During the consultation process we received a total of 10 responses that are listed below with the relevant feedback after internal consultation:

Diagram Mg) Timber Floor Joint Notching Detail

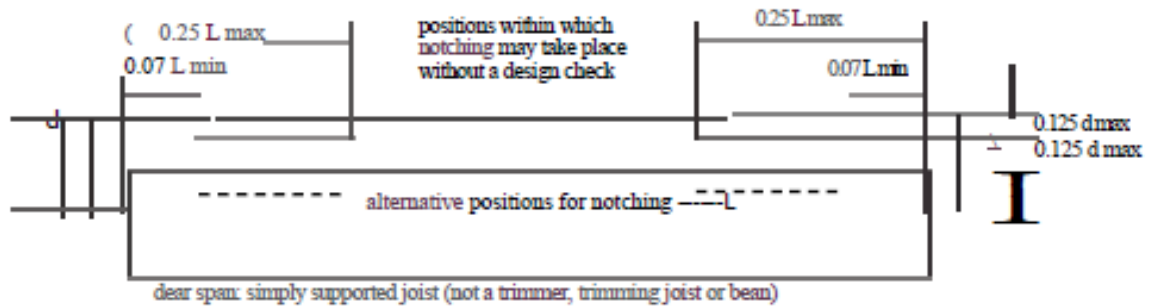
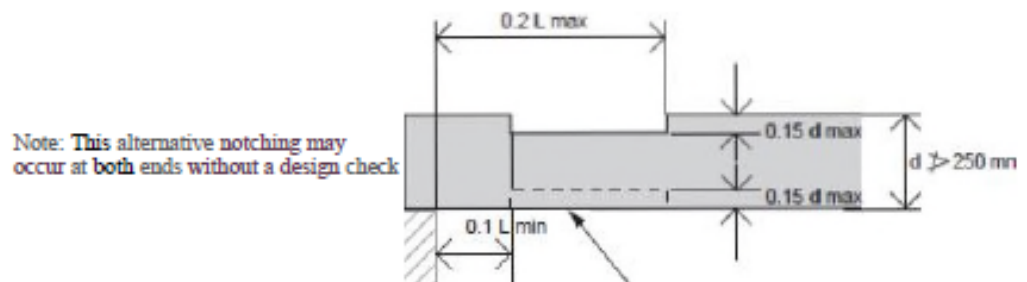
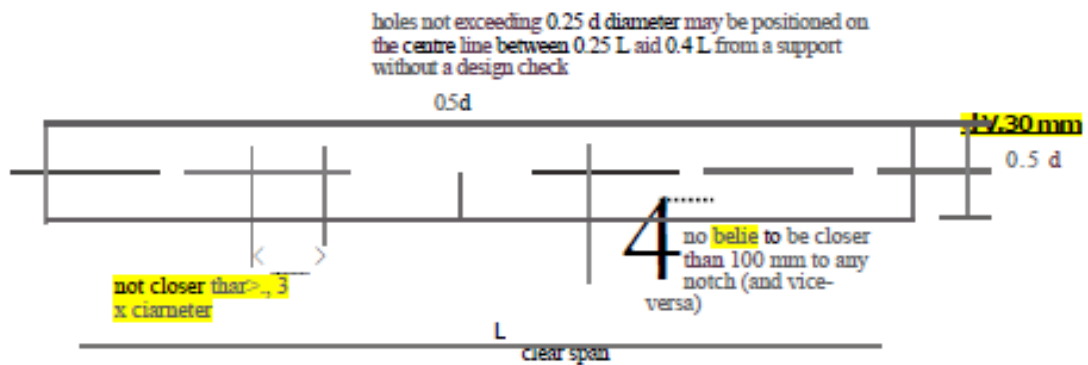
c) limits for drilling **None of these diagrams are clear**

(The diagrams submitted in this consultation response has been altered from the original diagrams in the document, we feel the original diagrams are extremely clear)
